APPLICATION NO.	FILING DATE	FIRST NAMED INVENTOR	ATTORNEY DOCKET NO.	CONFIRMATION NO.
10/786,754	02/25/2004	Tsuyoshi Okutani	848075/0067	3009
	7590 02/04/200 TH & ZABEL LLP	EXAMINER		
ATTN: JOEL E. LUTZKER			WANG, KENT F	
919 THIRD AVENUE NEW YORK, NY 10022			ART UNIT	PAPER NUMBER
			2622	
			MAIL DATE	DELIVERY MODE
			02/04/2009	PAPER

Application No.	Applicant(s)				
	10/786,754	OKUTANI ET AL.				
Office Action Summary	Examiner	Art Unit				
	KENT WANG	2622				
The MAILING DATE of this communication app Period for Reply	ears on the cover sheet with the c	orrespondence address				
A SHORTENED STATUTORY PERIOD FOR REPLY IS SET TO EXPIRE 3 MONTH(S) OR THIRTY (30) DAYS, WHICHEVER IS LONGER, FROM THE MAILING DATE OF THIS COMMUNICATION. - Extensions of time may be available under the provisions of 37 CFR 1.136(a). In no event, however, may a reply be timely filed after SIX (6) MONTHS from the mailing date of this communication. - If NO period for reply is specified above, the maximum statutory period will apply and will expire SIX (6) MONTHS from the mailing date of this communication. - Failure to reply within the set or extended period for reply will, by statute, cause the application

FIG.46

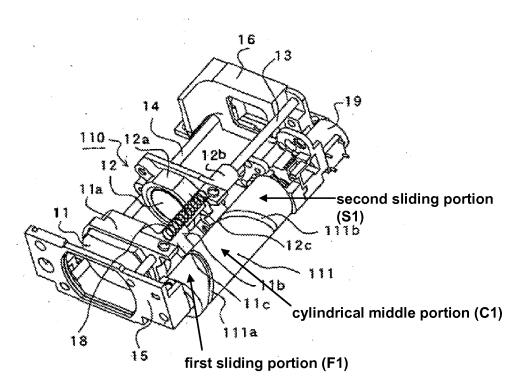
The examiner understands the applicant's arguments but respectfully disagrees with the applicant's assessment. In response to applicant's argument, it is noted that Fig 46 inherently shows the cam for zooming 111 has a cam base body having a generally cylindrical middle portion (C1) and a first sliding portion (S1) and second sliding portion (F1) formed at both ends of said middle portion. Fig 46 further inherently shows the a first cam groove 111a as a first stepped portion and a second cam groove 111b as a second stepped portion (please see figure below). Applicant's arguments are not convincing.

In response to applicant's argument on page 14 that the Examiner has failed to identify in the Disclosed Prior Art the claimed "first stepped portion..." and "second stepped portion

", it is noted that Fig 46 inherently shows the a first cam groove 111a function as a first stepped portion and a second cam groove 111b as a second stepped portion (please see figure above).

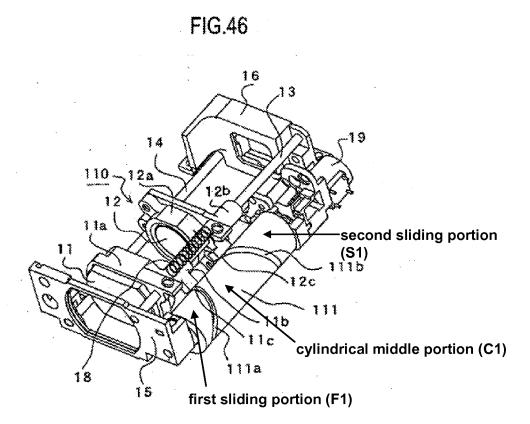
(S1) and second sliding portion (F1) formed at both ends of said middle portion, see Fig 46 below on next page) and said sliding portions having a smaller diameter than that of said middle portion, said cam base body further comprising a first stepped portion forming an approximately vertical plane between said first sliding portion and said middle portion thereby defining a cam plane of the first spiral cam groove (a first cam groove 111a) and a second stepped portion thereby forming an approximately vertical plane between said second sliding portion and said middle portion thereby defining a cam plane of the second spiral cam groove (a second cam groove 111b) ([0029]-[0030]);

- a first cam frame (first lens frame 11a, Figs 46-47) having another cam plane confronting the one cam plane (first cam plane 17a, Fig 45) of the first cam groove (a first cam groove 111a) and provided non-rotatably so as to be able to slide on one sliding portion ([0025]-[0029]);
- a second cam frame (second lens frame 11b, Figs 46-47) having another cam plane (second cam plane 17b, Fig 45) confronting the one cam plane (second cam plane 17b, Fig 45) of the second cam groove (a second cam groove 111b) and provided non-rotatably on the second sliding portion so as to be able to slide ([0025]-[0029]);
- a forcing device (a coil spring 18, Figs 46, 47) which connect the first and the second cam frames to the cam base body (a cam for zooming 111, Figs 46, 47) ([0029]); and

- cam groove inserting members (a protruded cam pin, 11c, 12c), each of which is received within one of the first and second spiral grooves (a first and second cam groove 111a and 111b) ([0029]).

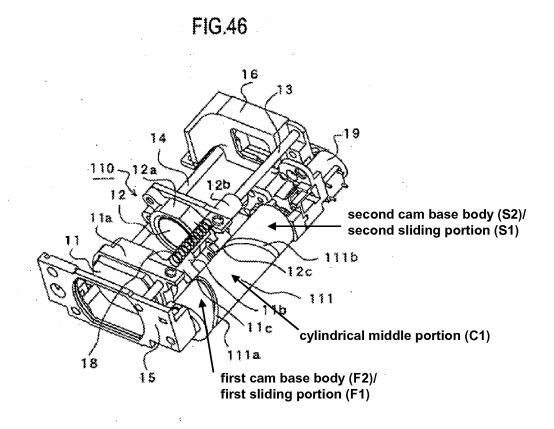
Regarding claim 12, AAPA discloses said cam based body (a cam for zooming 111, Fig 46) further comprises a first cam base body portion (F2, Figure below) having said first sliding portion (F2) at one end thereof and a second cam base body portion (S2) having said second sliding portion (S1) at one end thereof, said first cam base body portion (F2), and said second cam base body portion (S2) being connected to each other at ends opposite of said first (F1) and second sliding portions (S1) such that further comprising an adjusting

mechanism (a coil spring 18) which adjusts a distance between said cam plane of said first spiral groove (a first cam groove 111a) and said cam plane of said second spiral groove (a second cam groove 111b) may be adjusted in an axial direction the confronting cam planes of each of the first and the second cam grooves (the pressing function of the cam pin 11c or 12c is derived from a tensile force of a coil spring 18 which is fastened to tighten between a lens frame 11a and 12a. That is, the coil spring 18 is a spring for tensile force, one end of which is fixed to the lens frame 11a, another end of which to the lens frame 12a) (see Figure below).
